Reque	st for	Information	("RFI'7
-------	--------	-------------	---------

PROJECT: ISSUE DATE: 02-06-25 RFI No. 030

Harrison, Town-Village Recreation Center Phase 2

## Request for Information ("RFI")

### **ENLARGED ARCHITECTURAL SITE PLAN AT GAS RIG LOCATION**

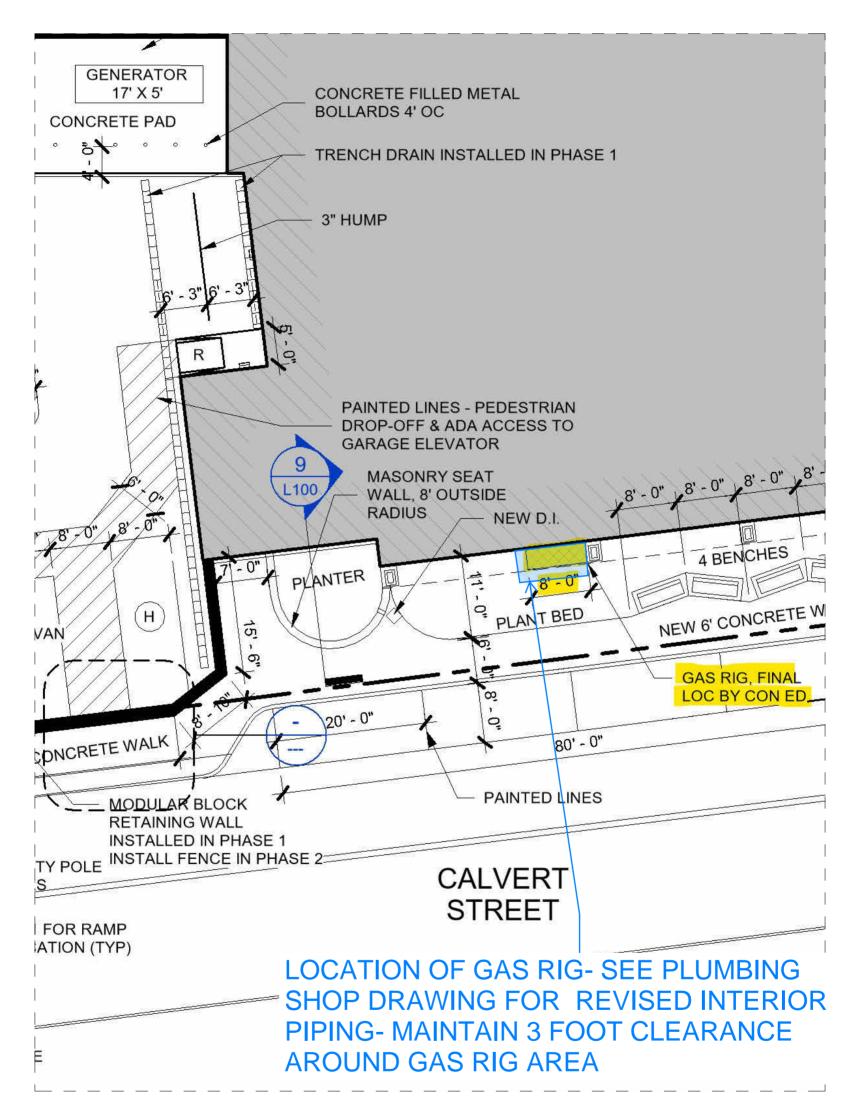
**RFIDESCRIPTION:** Can we have direction on the new Gas POE layout, along with a detailed drawing and narrative focusing on the additional drainage piping under the slab on the lower level.

Response includes an additional approximate 72 feet of gas piping to the Mechanical Room and deletion of the excavation at the original location.

Gas routing has been included on the latest garage plumbing shop drawing. Plumbing Contractor shall coordinate with Con Edison and shall open up gas case with them. Plumbing Contractor shall coordinate final location of gas meter rig with Architect.

See attached ASK-06 for relocation of the gas service into the building.

FINAL LOCATION TO BE COORDINATED WITH CON ED. MUST BE 3'+ FROM ANY LOUVERS
